# Final Product/Process Change Notification

Document #:FPCN23658ZS

<b>Title of Change:</b>	Wafer fab transfer to onsemi Gresham, Oregon USA from onsemi Fab2, Oudenaarde, Belgium related to Fab2 sale	
<b>Proposed Changed Material First Ship Date:</b>	01 Sep 2022 or earlier if approved by customer	
<b>Current Material Last Order Date:</b>	31 Mar 2022 #PD24322Z <i>Orders received after the Current Material Last Order Date expiration are to be considered as orders for new changed material as described in this PCN. Orders for current (unchanged) material after this date will be per mutual agreement and current material inventory availability.</i>	
<b>Current Material Last Delivery Date:</b>	31 Aug 2022 <i>The Current Material Last Delivery Date may be subject to change based on build and depletion of the current (unchanged) material inventory</i>	
<b>Product Category:</b>	Active components – Integrated circuits	
<b>Contact information:</b>	Contact your local onsemi Sales Office or <a href="mailto:Jelle.Genne@onsemi.com">Jelle.Genne@onsemi.com</a>

Figure 4. CAN Timing Parameters

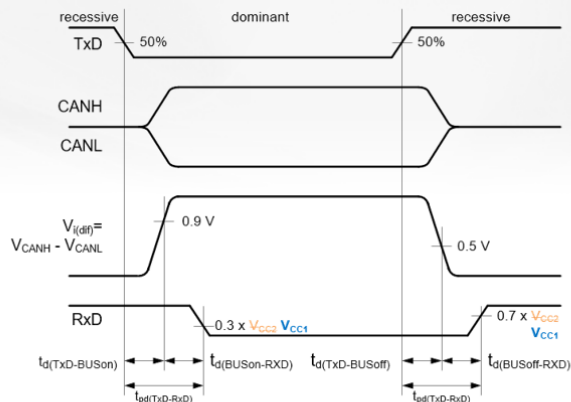
Figure 4 – CAN Timing parameters:

- Correct V<sub>CC2</sub> to V<sub>CC1</sub>

Figure 6 – State Diagram of the Functional Operating Modes:

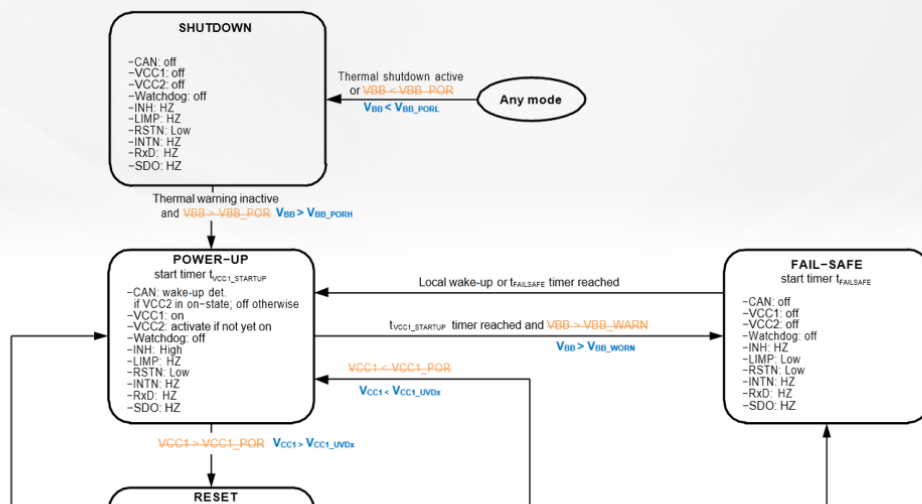
- Refer to correct threshold levels / names
- Typo corrections | • Replace  $t_{VCC1\_RESET}$  and  $t_{VCC1\_2ND\_RESET}$  by  $t_{RESET}$  and  $t_{2ND\_RESET}$

Figure 7. State Diagram of the Special Operating Modes – Flash Mode

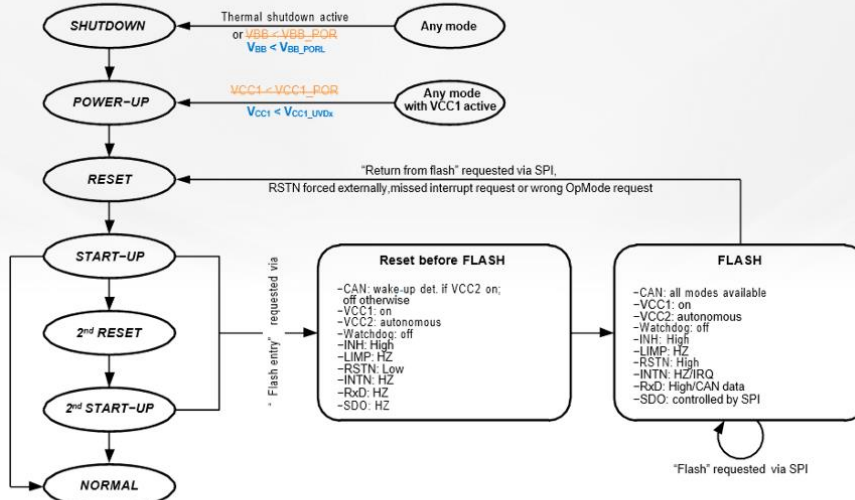
Figure 7 – State Diagram of the Special Operating Modes – Flash Mode:

- Refer to correct threshold levels / names | • Typo correction (wakeup -> wake-up)

Figure 8. State Diagram of the Special Operating Modes – Software Development and Factory Flashing mode

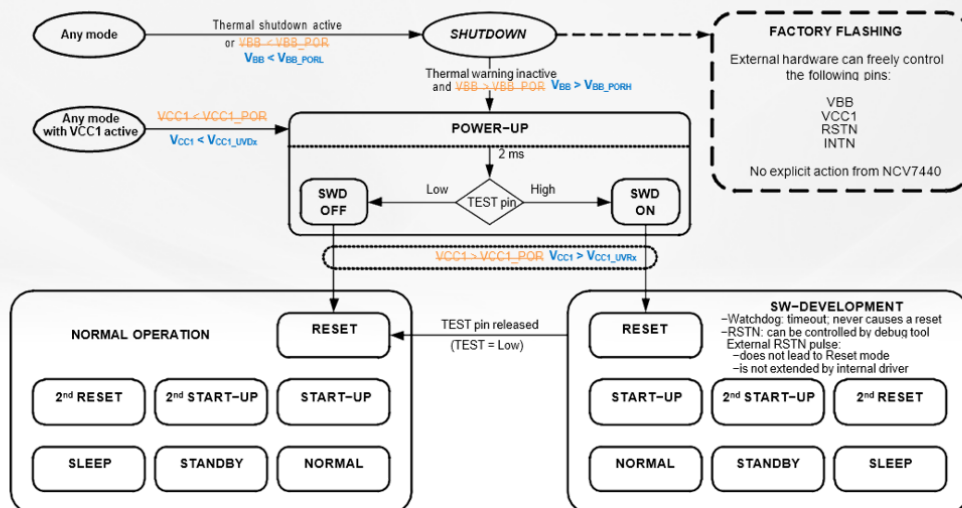
Figure 8 – State Diagram of the Special Operating Modes – Software Development and Factory Flashing mode:

- Refer to correct threshold levels / names

Figure 10. State Diagram of the V<sub>CC2</sub> Regulator Control

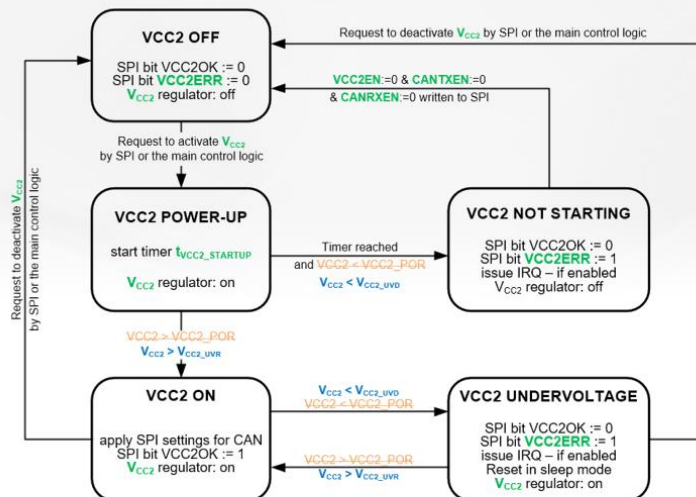
Figure 10 - State Diagram of the V<sub>CC2</sub> Regulator Control:

- Refer to correct threshold levels / names | • Typo correction (in green)
